January 16, 2025

Planning Commission

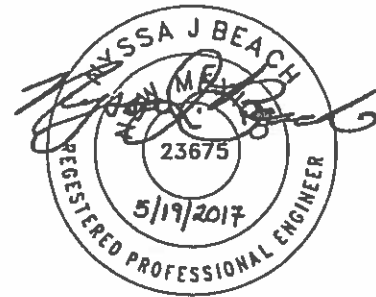
REVISIONS (OR CHANGE NOTICES)
